Item Name: Bubble Window, RH

DESIGN <i>qp</i>	DRAWN BY LE	DART AEROSPACE LTD HAWKESBURY, ONTARIO, CANADA	
CHECKED <i>qp</i>	APPROVED <i>[Signature]</i>	DRAWING NO. DSI 9329	REV. B SHEET 1 OF 1
DATE 06.06.26		TITLE BUBBLE WINDOW INSTALL MOD.	SCALE NTS
A	06.04.25	NEW ISSUE	
B	06.06.26	CHG TO EFFECTIVE AFTER CHG 002

DART SERVICE INSTRUCTION

TO AMEND INSTALLATION INSTRUCTIONS IIN-D044-713 REV. A

FIGURE 1

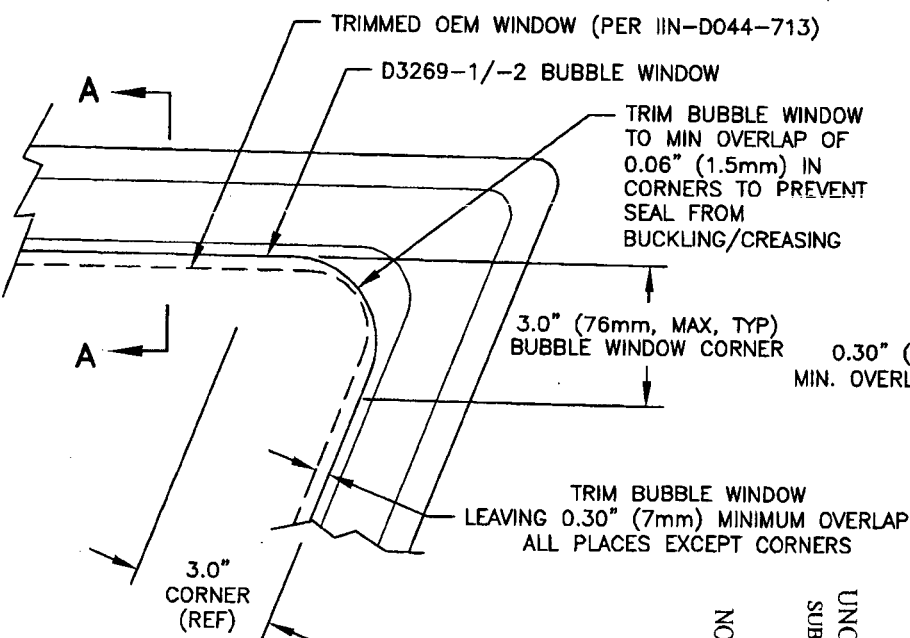
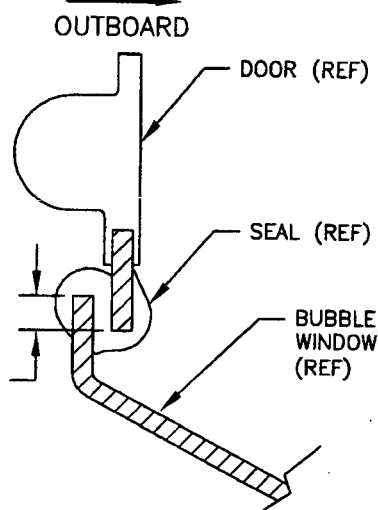
PURPOSE: For the D044-713-013/-014 kits supplied after CHG 002, the D3267-1/-2 bubble windows have been supplied untrimmed to allow for easier installation in the field. The installer must trim the windows in accordance with these instructions prior to installation.

- 1) Modify the R44 crew door per items 3.2.1 and 3.2.2 of Installation Instructions IIN-D044-713 Rev.A.
- 2) Fit and trim the D3269-1/-2 Bubble Window to match the cutout in the door as follows: The bubble window must be a minimum of 0.30" (7mm) larger than the cutout in the OEM window as shown in the figure below. However, in the corners of the window, it is acceptable to trim a 0.06" minimum overlap (1.5mm) to help prevent the D2126-0903 Seal from buckling/creasing in the corners. The edge of the bubble window must be deburred to a smooth finish.
- 3) Continue installing the bubble window per items 3.2.3 through 3.2.5 of the installation instructions.
